# WATER QUALITY MEMORANDUM

## Utah Coal Regulatory Program

RE: Four Quarter of 2014 Water Monitoring, Alton Coal Development LLC, Coal Hollow, C/025/0005, Task ID #4736

Figure 1. Well Y-102: Alluvial well in upper Sink Valley to the east of pit 9 in permit area.

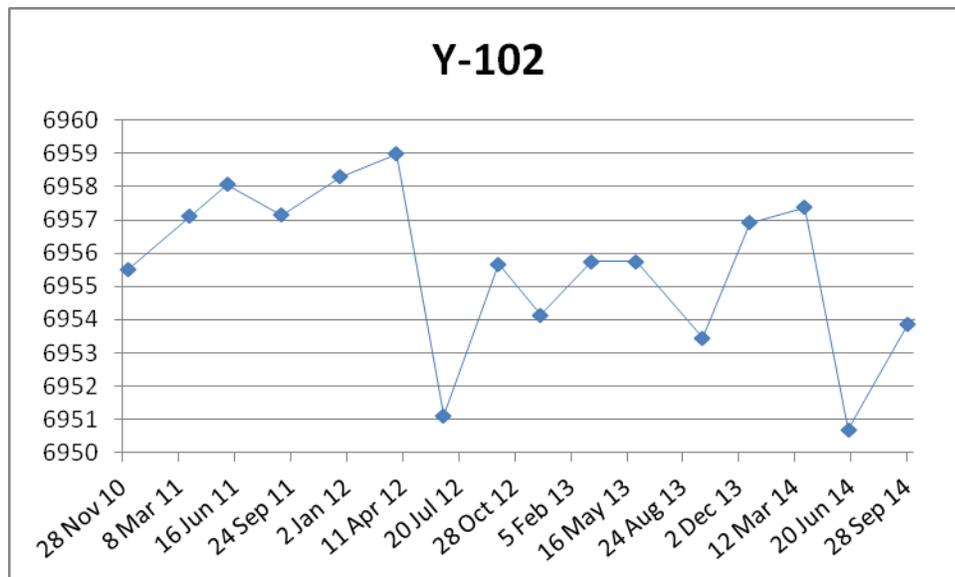
Well 102 is rebounding, the lower values seen may be a seasonal/climatic pattern (Figure 1).

None, however tracking the water elevation in well Y-102 would be worth continued examination. Continue to monitor elevated selenium in springs, streams, and wells.

Figure 2. Elevated Selenium levels at Spring, Stream, and Well sampling locations in Q2 2014.

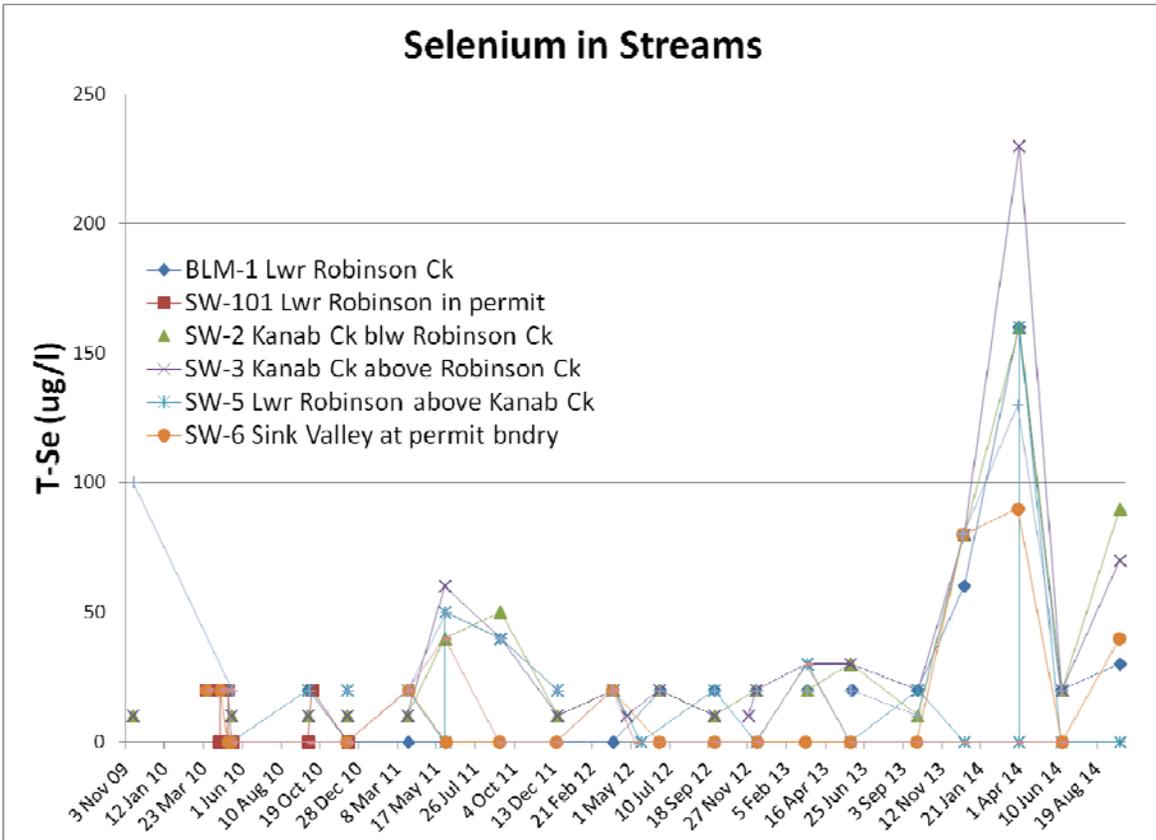
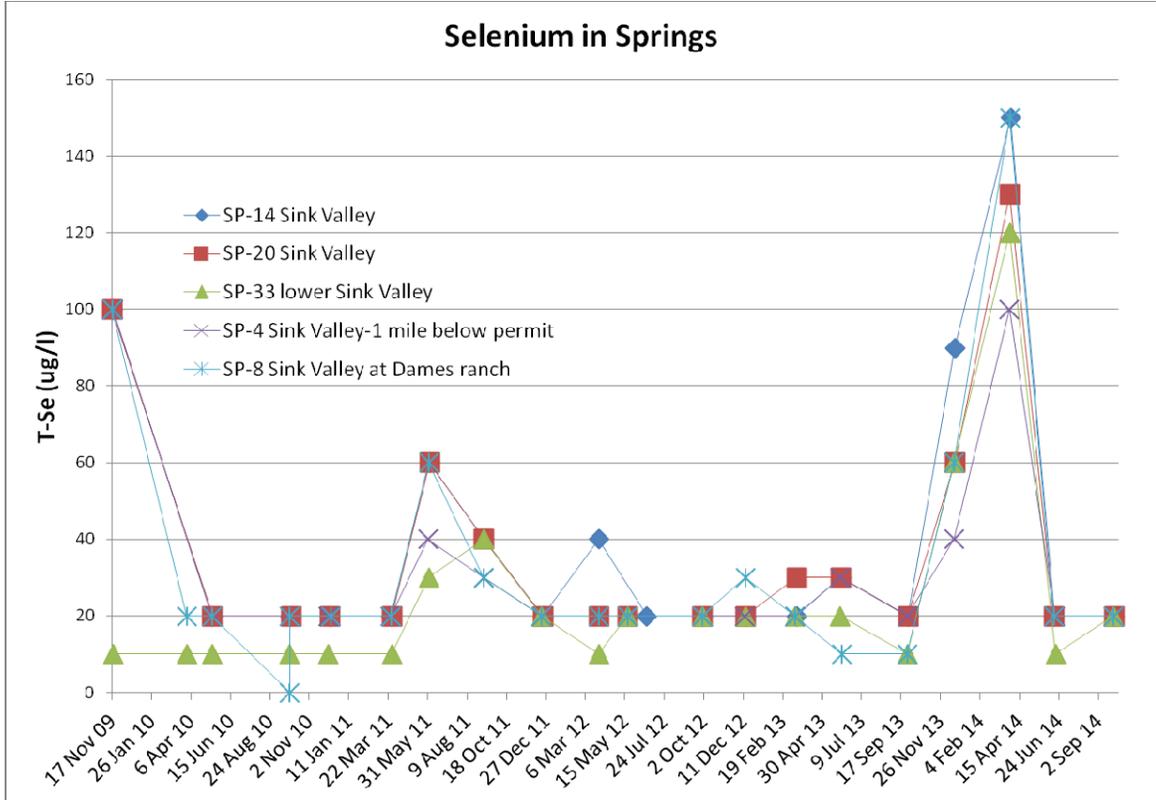
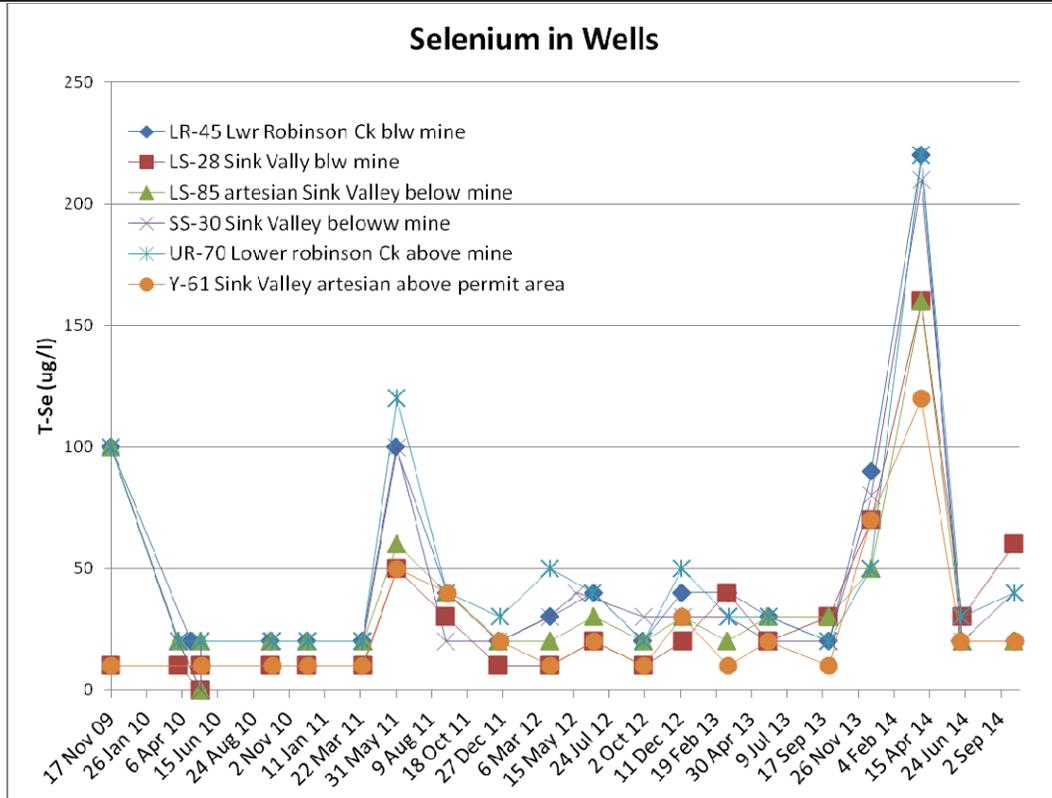
See Total Selenium levels in Streams (Figure 2). There was a significant spike in levels early in the year that have since gone down. Chemtech-Ford had a difficult time processing Selenium this quarter. Up to date graphs will be give 1Q 2015.

See Total Selenium levels in Wells (Figure 2). There was a significant spike in levels early in the year that have since gone down. Chemtech-Ford had a difficult time processing Selenium this quarter. Up to date graphs will be give 1Q 2015.
